**CITY OF TEMPE  
DEVELOPMENT REVIEW COMMISSION**

**Meeting Date: 03/10/2015  
Agenda Item: 3**

**ACTION:** Request for an Amended Planned Area Development and a Development Plan Review for a new five-story, 228 room hotel and associated restaurant for DISCOVERY BUSINESS CAMPUS – SITES 1 & 2, located at 7200 South Price Road. The applicant is Gammage & Burnham P.L.C.

**EXTERIOR ELEVATIONS**  
SCALE: 1/16" = 1'-0"

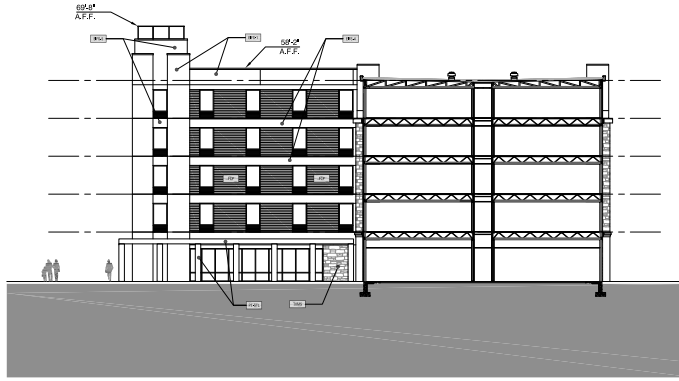
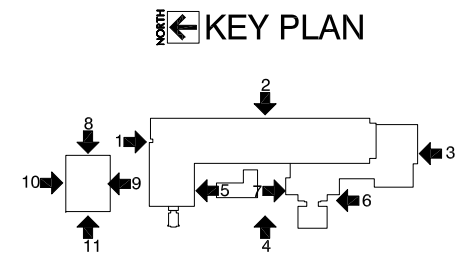
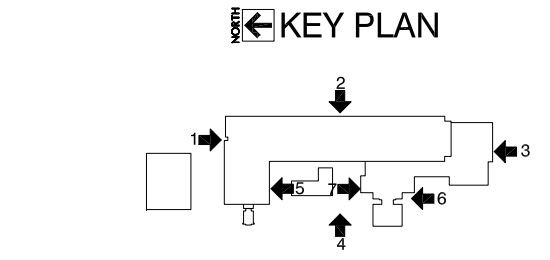
13. Provide secure roof access from the interior of the building. Do not expose roof access to public view.
14. The hotel elevations shall be modified to provide screening that is equal to or greater in height than the rooftop mechanical units.
